SUBSURFACE WASTEWATER DISPOSAL SYSTEM APPLICATION

Street: Bond Brook Road

Last: Arnold First: Paul

Replacement System Variance Request

SITE PLAN

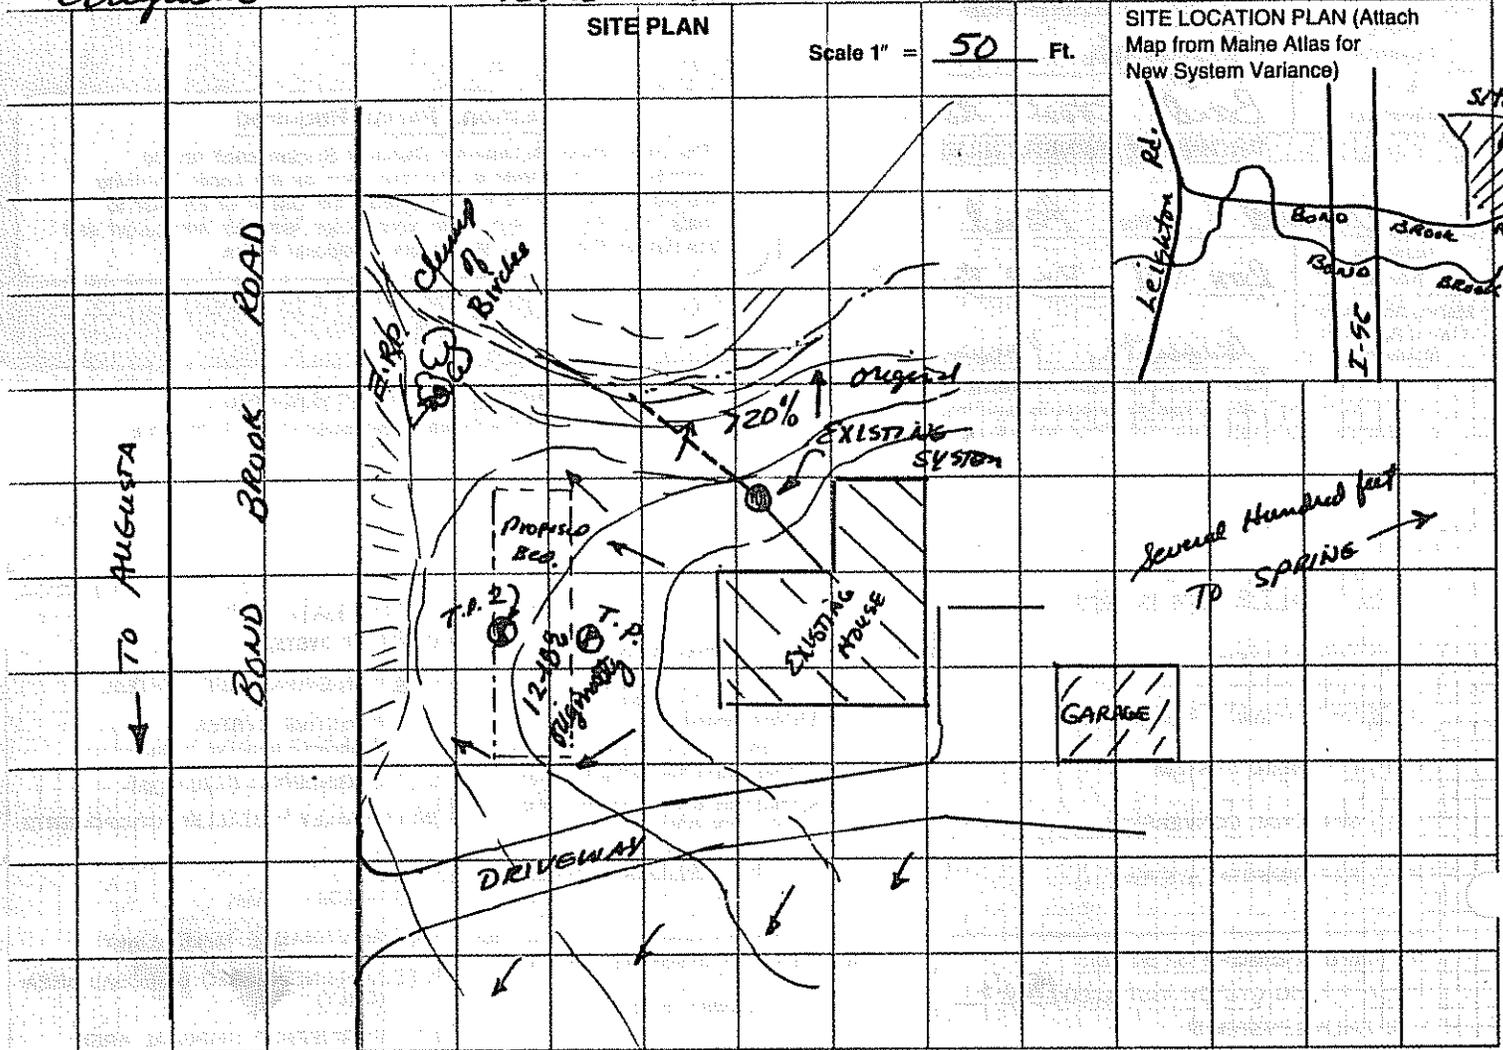
Proposed to cut bank on uphill side 6-8 feet to level point on downhill side and replace area with good clean fill @ least 36" and 48" on uphill & downhill side respectively. This is the only alternative practical for applicant.

Comments: *I do not recommend this system being considered by you out find due to sec 9 page 15.2 it is beyond my authority to grant a variance without Dept approval 8/8/83*
Robert B. Sturtevant
LPI's Signature
